# Dowdeswell

## Product Improvement Notice

Machines affected:- UCN Bodies		P.I.N. No.:- 076	
Compiled:- PHC	ECN Ref.:- N/A	Date:- 25/06/98	Sheet 1 of 1

Shield Plate

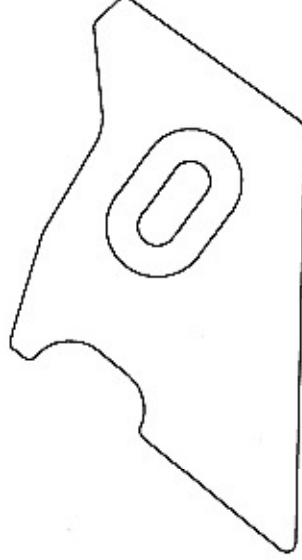
A shield plate is now available for UCN bodies to protect the side of the frog when ploughing in abrasive conditions. Existing mounting bolts etc. can be used and no modification to the frog is required.

The part numbers for the shield plates are:

Right Hand 1411298

Left Hand 1411299
